URGENT FIELD SAFETY NOTICE

Tibial Components / Modular Joint Component Units of
Endo-Model - M Modular Knee Prosthesis System

Tibial Components of
Endo-Model SL Rotational and Hinge Knee Prosthesis System

Endo-Model SL

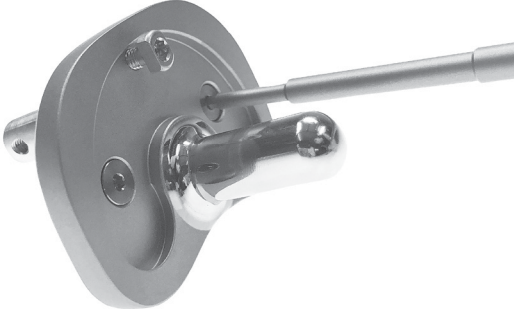
If a Tilastan proximal spacer is to be used and either one or both blind screws of the modular tibial component cannot be loosened, then the following modified surgical technique is to be performed.

= screw removal impossible?

<p style="color: green;">It has to be observed that a homogenous cement mantle between the Tilastan proximal spacer (full & half) and modular tibial component is ensured. The cement mantle should be 1-2 mm thick.</p>

Endo-Model – M

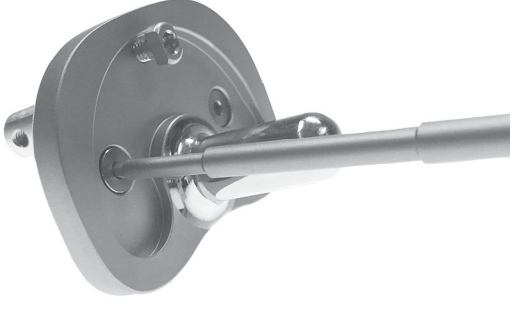
If a Tilastan proximal spacer is to be used and either one or both blind screws of the modular tibial component cannot be loosened, then the following modified surgical technique is to be performed.

<p style="color: red;">✘ = screw removal impossible?</p>

<p style="color: green;">It has to be observed that a homogenous cement mantle between the Tilastan proximal spacer (full & half) and modular tibial component is ensured. The cement mantle should be 1-2 mm thick.</p>
